## Application for Works Approval

<b>Works Approval Number</b>	W6601/2021/1
<b>Applicant</b>	Northern Star (Thunderbox) Pty Ltd
<b>ACN</b>	107 154 727
<b>File number</b>	DER2021/000505
<b>Premises</b>	North Eastern Goldfields Operations Mining tenements: M36/512, M36/582, M36/585
<b>Date of report</b>	3 May 2022
<b>Decision</b>	Works approval granted

**Figure 2: Extended TSF diversion infrastructure**

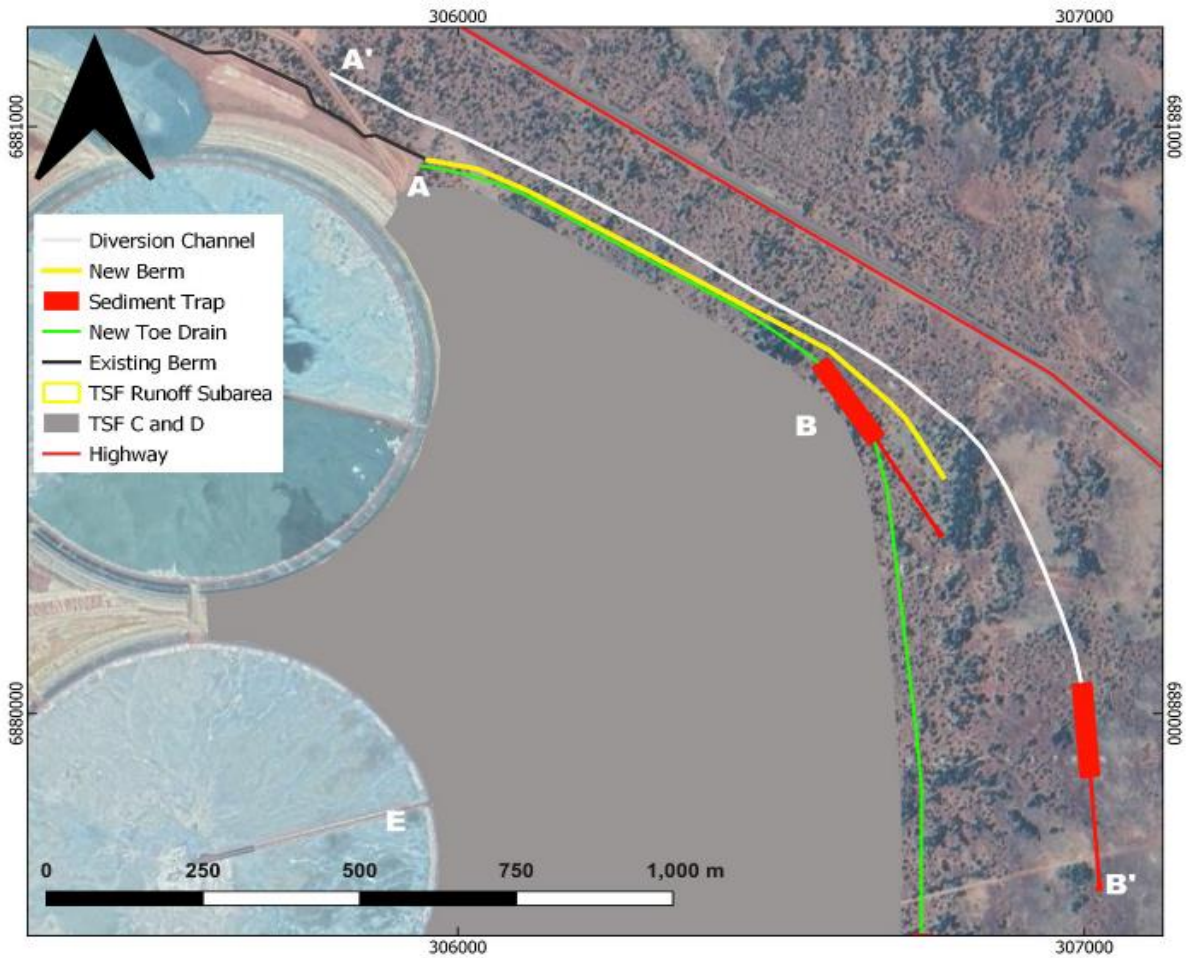
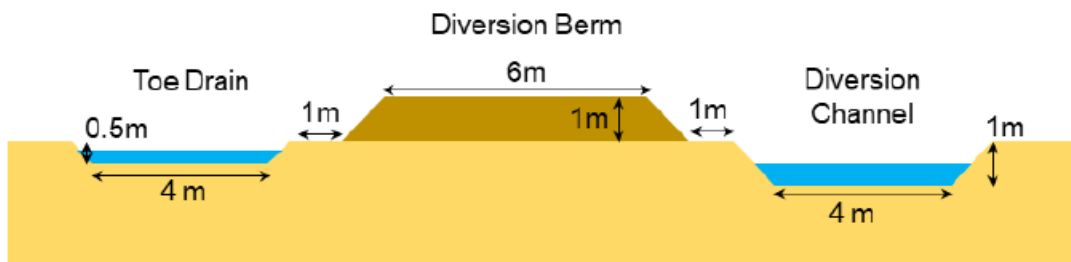
Condition	Summary of applicant's comment	Department's response
<b>Decision report</b> Table 1: Proposed applicant controls	Applicant confirmed the dust controls used during construction, TSF freeboard of 500mm and TSF toe drain water management.	Details in table updated.
	Applicant responded to request for details on actions regarding management of dusting from dry tailings cells prior to lifts with:  <i>'During the time between lifts, dusting of the inactive cell is not expected as the material will retain moisture under a salt crust. Water component of the tailings will be hypersaline which will allow the crust to form.'</i>	<p>The Delegated Officer notes that the period between lifts, when a TSF cell will be required to dry out, is likely to be shorter than a period of Care and Maintenance. However the Works Approval Holder is advised that, as per the risk analysis for ambient dust emissions in Section 3.3 of this report, the tailings produced at the North Eastern Goldfields Operations have historically produced significant amounts of ambient dust when dry. The assumption that salinity forms a crust sufficient to provide dust suppression for an extended period of time has been proven to be incorrect at this premises.</p> <p>This ability of the TSF to generate dust when dry has caused the area surrounding the current TSF to be recorded as a contaminated site with the classification of 'remediated for restricted use'.</p> <p>The risk during the period of limited time operations covered by this works approval is expected to be low so further conditions are not required. The Works Approval Holder is however, advised to consider the dust management of dry tailings during long term operation of the tailings cells when submitting an application to amend the licence.</p>

Condition 11, Table 4	Freeboard is 500mm.	Details in table updated.
